BRISTOL PORT AND CHANNEL DOCK.—SECTION OF EAST WALL.

ABERDEEN HARBOUR.—PROPOSED EXTENSION OF NORTH PIER.

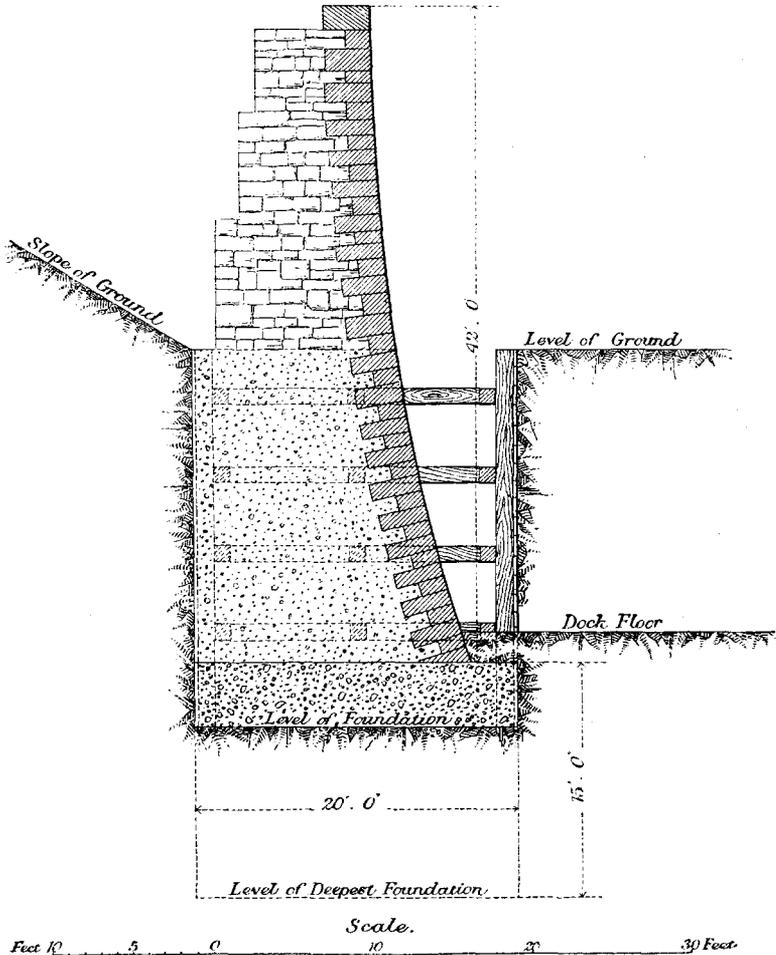
Mr. BRUNLEES said, about six years ago he had used concrete blocks for the foundations of a dock at King's Lynn, and also concrete for pitching the slopes of the dock. Those slopes had been exposed for six years to the weather and to the bumping action of vessels, and he was glad to say they were as sound as when put down. The Papers did not deal with any great extent of work, but they were valuable in pointing out the way in which similar works might be conducted. The breakwater at Aberdeen had been, no doubt, conducted very successfully. His attention had, however, been drawn to one item, namely, that £46,000 worth of work had been done at an expense of £30,000 for plant, preparatory works, and buildings, which seemed an enormous proportion. He was at present using cement concrete for the dock at the mouth of the Avon, near Bristol. The walls (Fig. 1) were built in a trench, piles being driven on each side. Stretchers were then introduced as the excavated material was taken away. The foundations were of blue lias concrete generally to a depth of 6 feet below the level of the dock floor, but at other points, where the ground was weak, to a depth of 17 feet below the same level. On the blue lias concrete, and from 2 feet below to 18 feet above the dock floor, the wall was built of cement concrete faced with Pennant stone. The concrete was tipped into the excavation from the surface out of barrows, and at the back it was rammed against the piles and poling boards. The front of the wall was carried up in rubble at the same rate at which the cement concrete was put in. The upper part of the wall was of coursed rubble of the ordinary description. It was found that in twenty-four hours the concrete was well set. For a work of that kind, where the ground was weak and slippery, the method pursued was very appropriate, as it tended rapidly to consolidate the cement concrete, and he had every reason to be satisfied with

the results. The lias concrete cost 9s., and the cement concrete 14s. per cubic yard. To cheapen the cost of the latter he had tried mixing it with blue lias, but had not obtained the object hoped for.

Works, was 350 lbs. per square inch, or 787 lbs. on $2\frac{1}{4}$ inches. He should be glad to know the cost of rubble at Aberdeen, for the purposes of comparison. Upwards of five hundred experiments had been made for Mr. Brunlees, which justified the course taken by him for the dock near Bristol, in keeping the lime and cement concrete for different parts quite distinct. No advantage would have been gained by using a mixture of lime and cement.

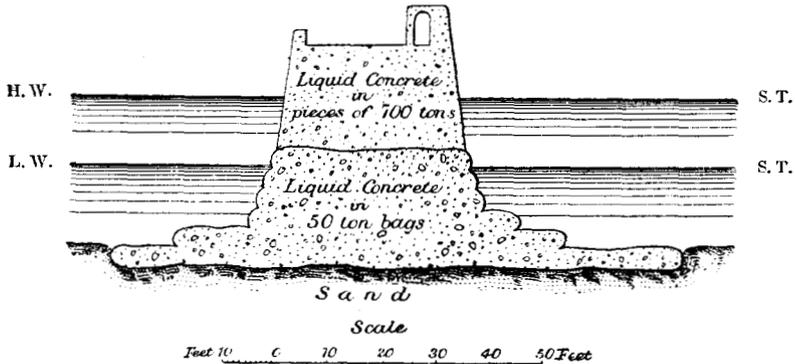
In the extension of the North Pier, about to be carried out, a section of which was shown in Fig. 2, and of which a model was exhibited, the foundation was sand, with solid ground at a depth of 7 feet below the surface. The whole of the submarine part, from the foundations to about 3 feet above L. W. O. S. T., a height of 22 feet, was to be formed of bags, each containing 50 tons of liquid concrete. A wide platform of these bags would be first laid as a foundation, and would be left to settle into the sand. When consolidated by the action of the waves, bags of concrete would be deposited on it, so as to bring the surface above low water, above which the work would be entirely of concrete deposited liquid in frames, in pieces of about 700 tons each. The 50-ton bags would

be deposited by a hopper barge, similar to that used for depositing dredgings, except that the slope of the well in the middle of the vessel would be modified. The precise spot for the bags would be fixed by lines ranged at right angles to one another by marks
